BRUNSWICK STEAM ELECTRIC PLANT, UNIT 1 AND 2 NRC DOCKETS 50-325 & 50-324 OPERATING LICENSES DPR-71 & DPR-62 REQUEST FOR LICENSE AMENDMENT RESPONSE TIME TABLE RELOCATION

MARKED-UP TECHNICAL SPECIFICATION PAGES - UNIT 1

MARKED-UP TECHNICAL SPECIFICATION PAGES - UNIT 2

TABLE 3.3.2-3 (Continued)

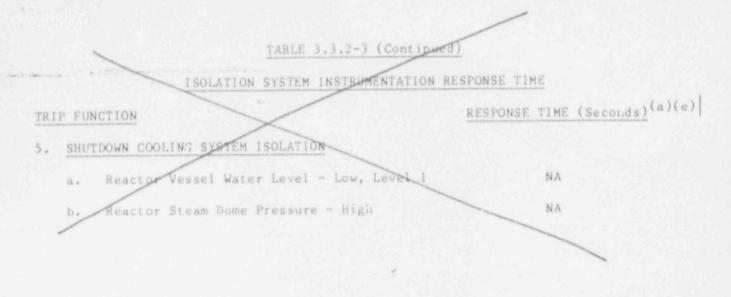
DELETE - RELOCATED TO UFSAR
